June 3, 1971

ADDENDUM #1

SACRAMENTO COMMUNITY CENTER COMPLEX

13th and 14th Streets,
J and L Streets,
Sacramento, California

ADDENDUM NO. 1
ITEM #12
BALCONY GRAB BARS

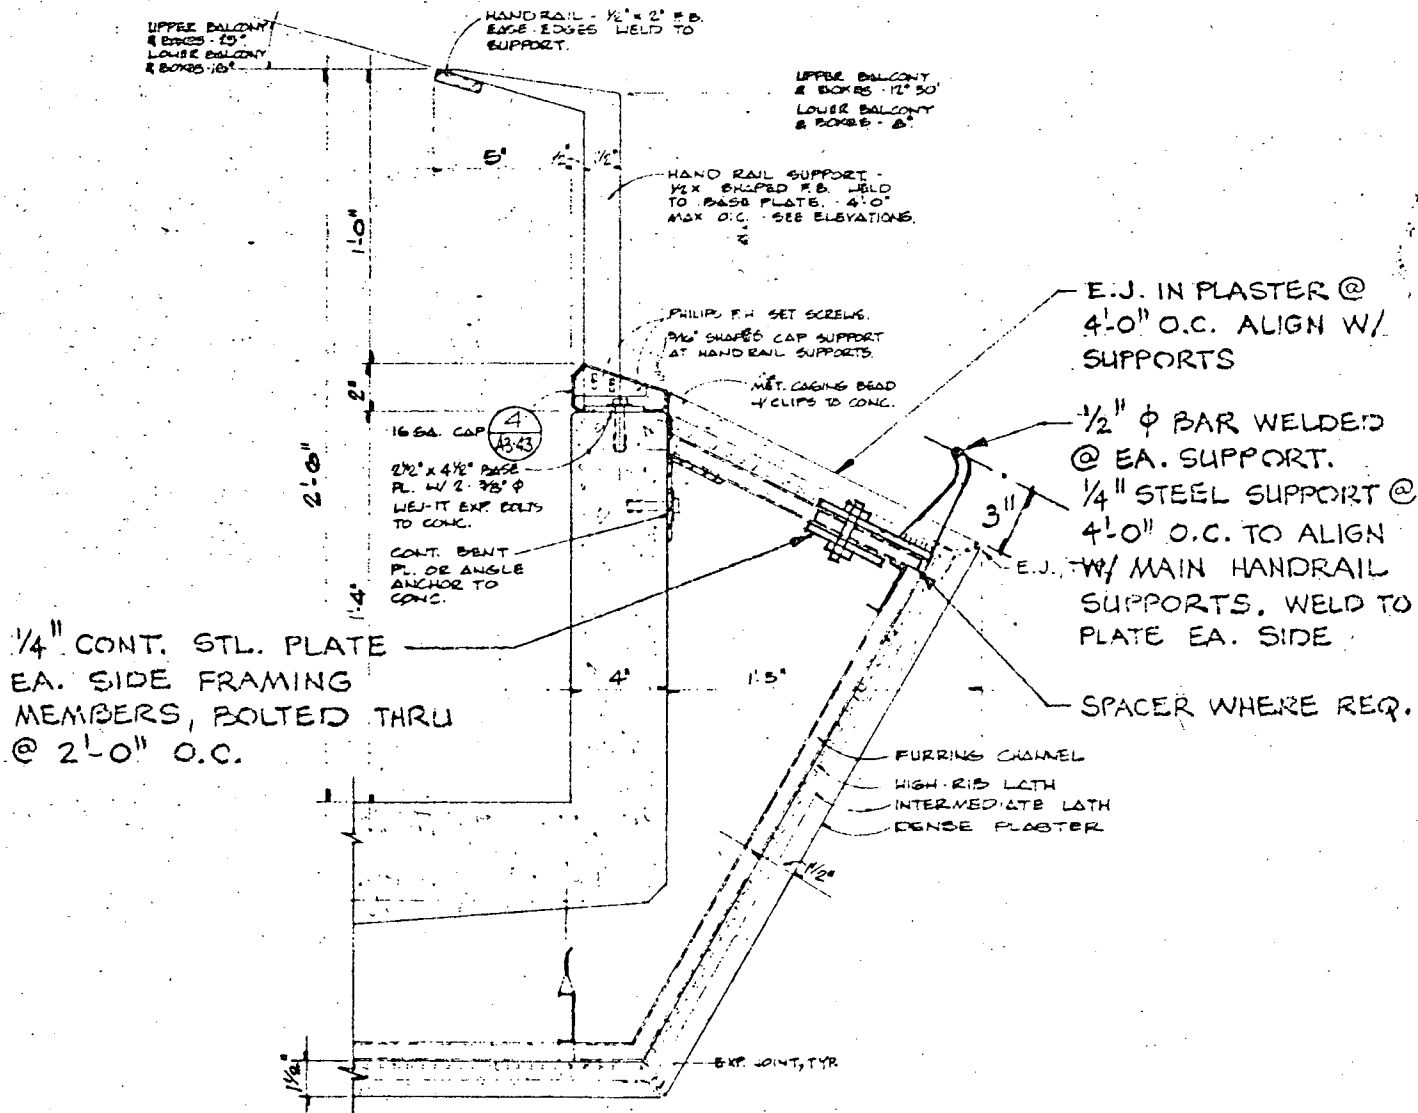
Reference: Drawings - Sheet A3-43
Addenda Drawing No. 1
Specifications - Volume I
SECTION 5E - MISCELLANEOUS METAL
Page 5E-1

"Delete Detail 1 on Sheet A3-43." Replace that detail with
Addenda Drawing No. 1.

Include material under Handrails and Railings in Section 5E.
